N6 Galway City Ring Road

Schedule of Additional Environmental Commitments Updated 20 October 13 March 2020

GCOB-4.04-019

Issue 1 Issue 2 | 13 March 2020 | 20 October 2020

Planting Plan at Aughnacurra Estate

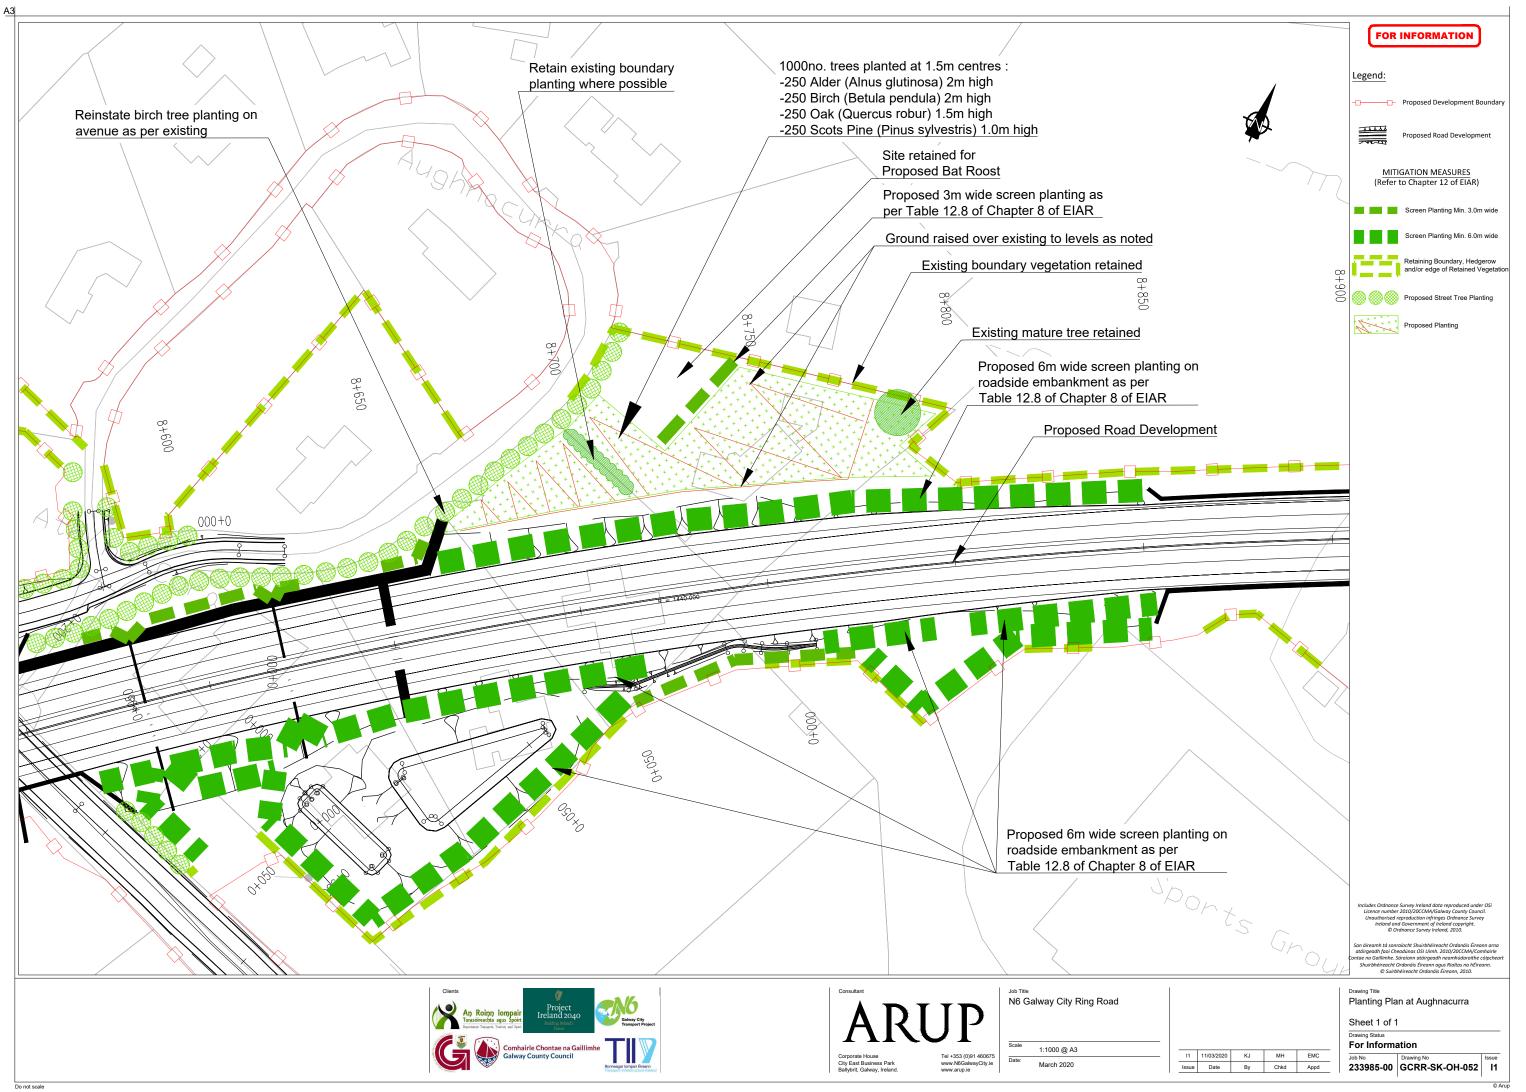
| Ref No. | Stage | Commitments |
|---------|-------|---|
| 12.41 | C | A grass verge with birch tree planting will be established to either side of the new entrance avenue into Aughnacurra Estate to match the character of the existing entrance. |
| 12.43 | C | Ground levels within the residual lands at properties 539 and 540 shall will be raised back towards the proposed road development and planted with 1000 no. trees of between 1.0 and 2.0m in height in accordance with the details set out on Figure GCRR-SK-OH-652 in Appendix A.21.2. The soil grading and planting shall not interfere with the proposed Bat Roost Structure in property 540 |

Habitat Donor and Receptor Sites

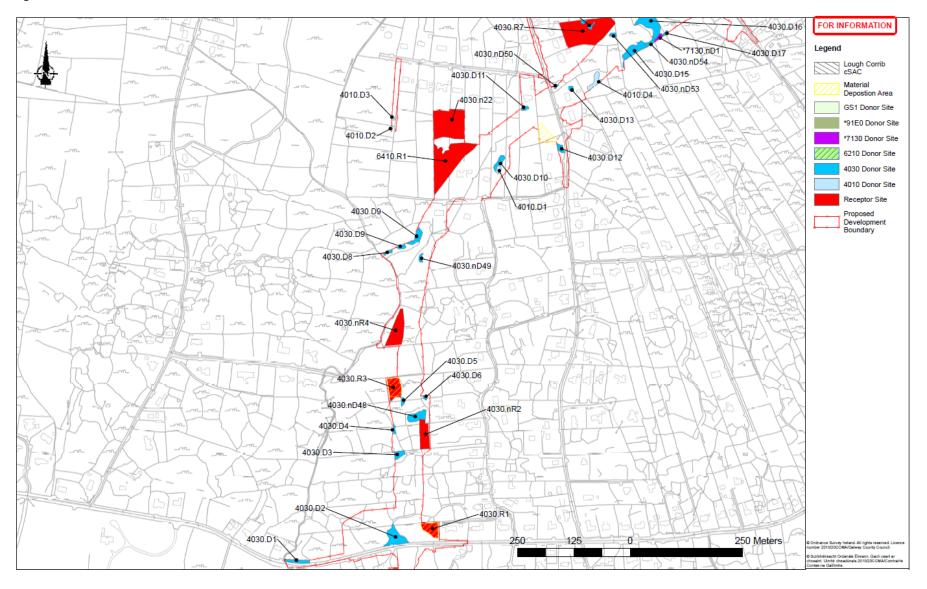
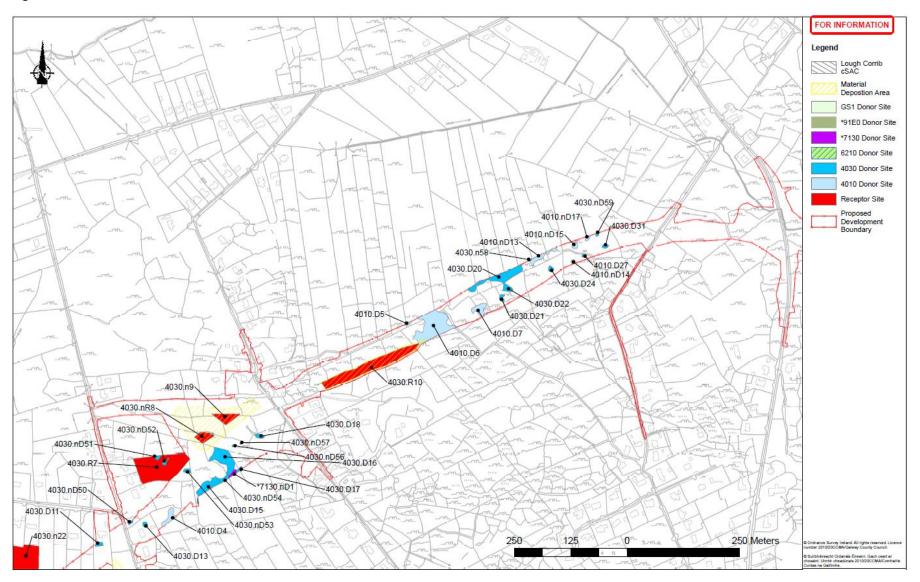
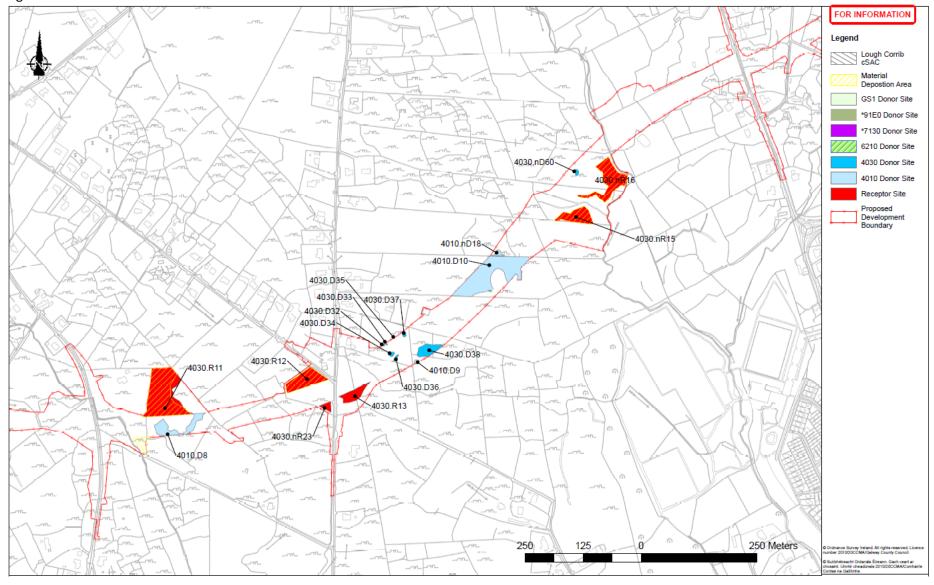
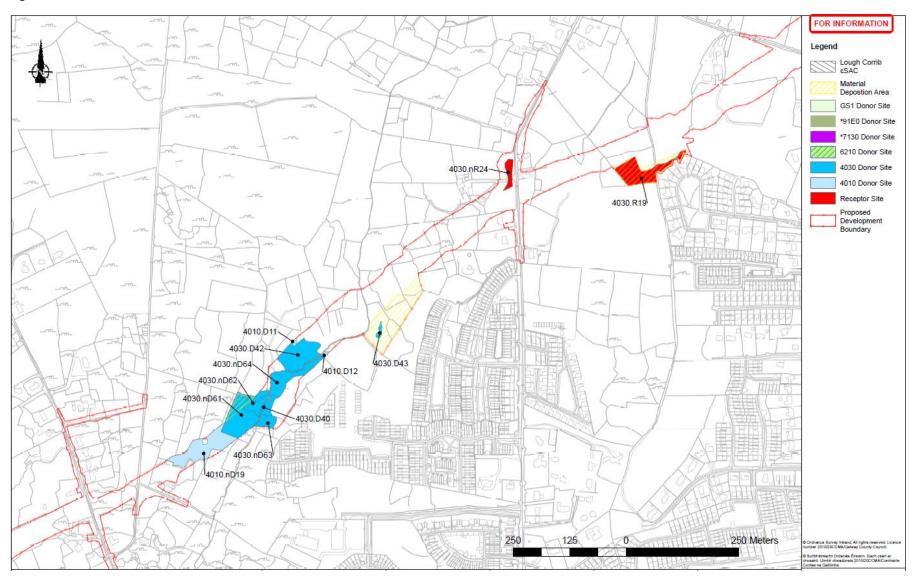
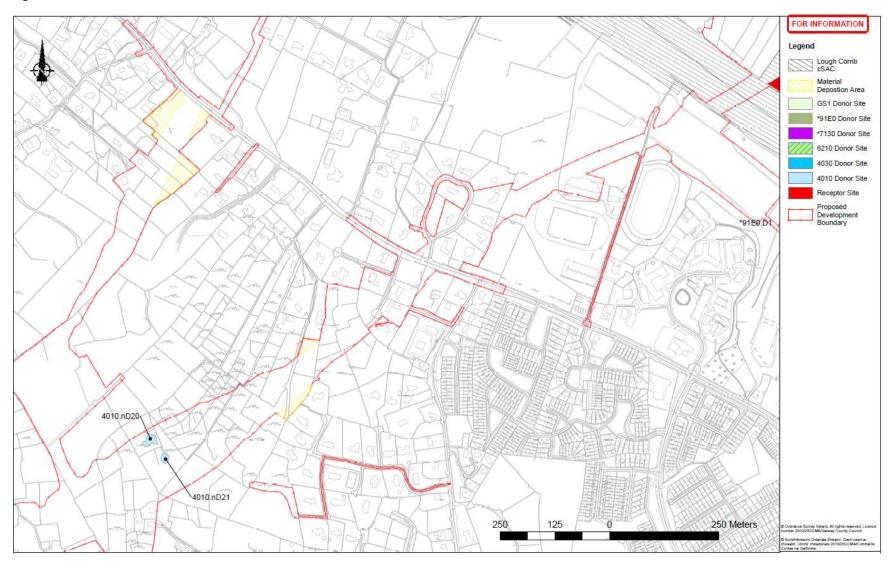
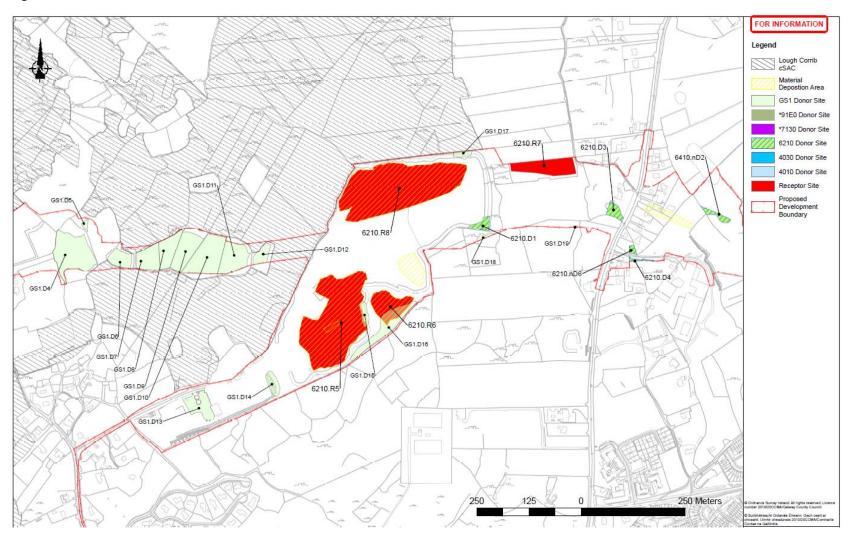
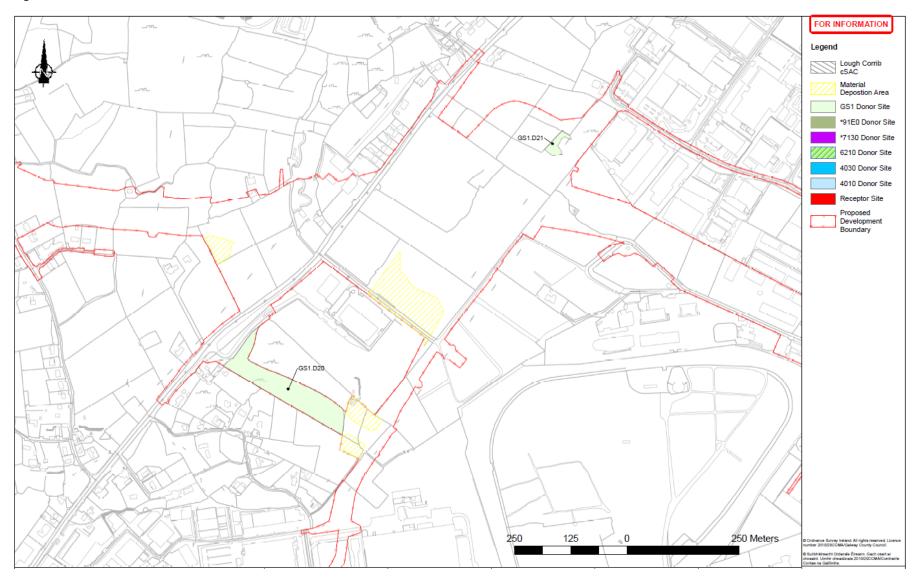
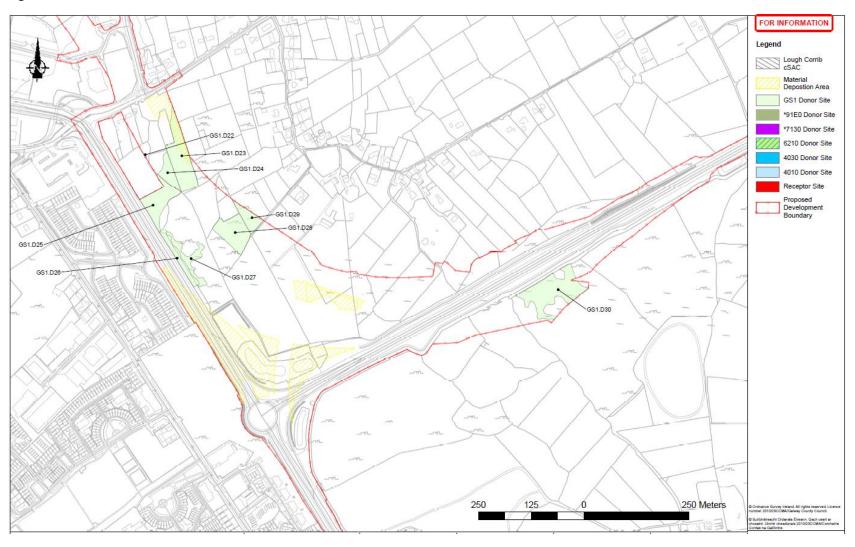
| Ref No. | Stage | Commitments |
|----------------------|------------|--|
| 8.1 <mark>9 8</mark> | C/O | Areas of compensatory habitat will be created, managed and monitored as set out in the Compensatory Habitat Management Plan in Appendix A.8.26 with locations of donor and receptors sites shown on Figures 1-9 in Appendix A.21.3 to this Schedule of Additional Environmental Commitments (these figures are the final updated figures which replace, updated from the figures included in |

| Ref No. | Stage | Commitments |
|---------|-------|--|
| | | Soils and plant material (including turves) from all 4030 donor sites will be the primary method used for dry heath habitat translocation and creation. The locations of all 4030 donor and receptor sites are presented in the appendix to this Schedule of Environmental Commitments. |

Figure 1: Area proposed for Barn Owl Habitat Enhancement

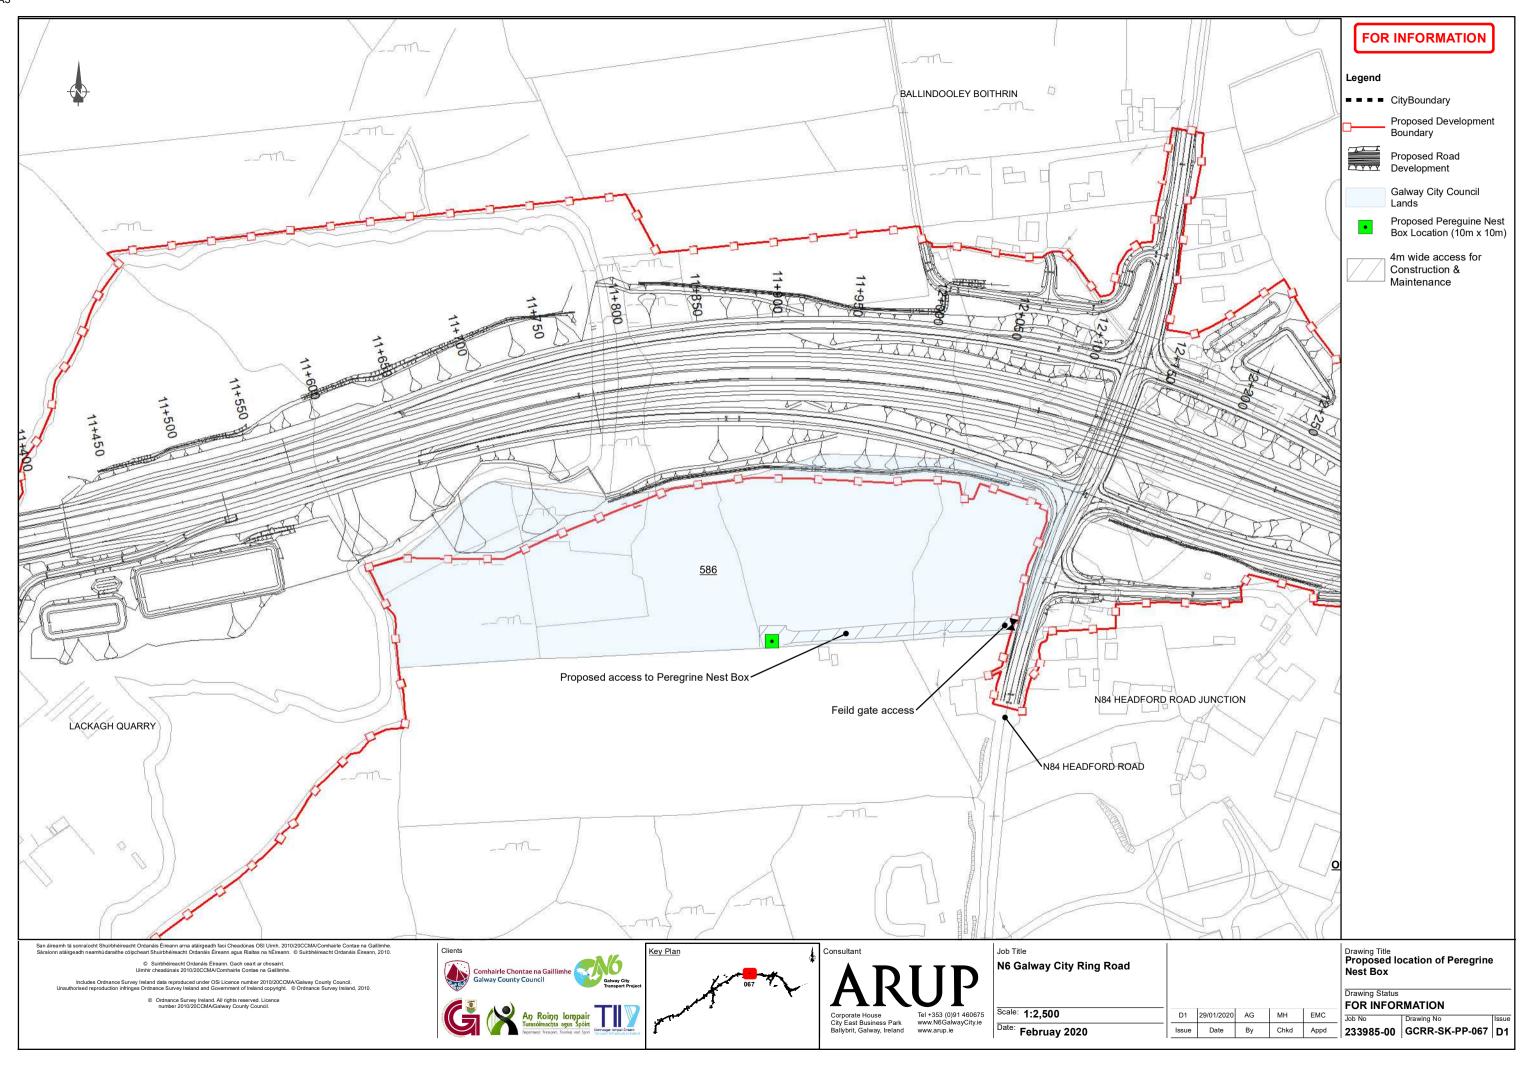
| Ref No. | Stage | Commitments |
|---------|-------|---|
| | | To establish and maintain rough grassland habitat for barn owl, lands to the west of the proposed road development at Menlo Castle (see Figure 1 in Appendix A.21.4 of this Schedule of Environmental Commitments) will be grazed annually by cattle for a three month period between July and October at a stocking rate of 0.35 livestock units/ha. |

Figure 3: The proposed location for a purpose-built tower to accommodate a nest box for Peregrine (shown by the red pin)).

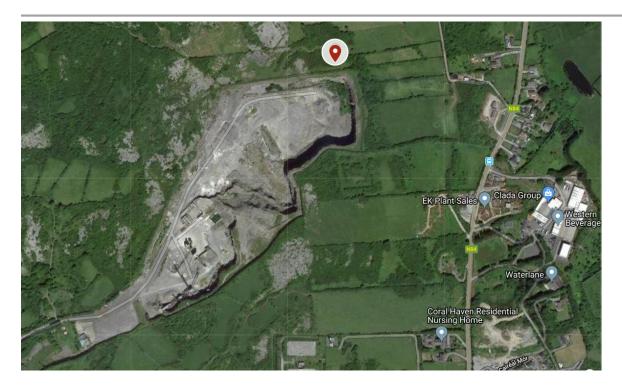
The area within the proposed development boundary for the proposed road development to the north of the nest site used in 2016/2017, in the north east corner of the quarry would provide a suitable location for the purpose-built tower, as shown in Figure 3 below.
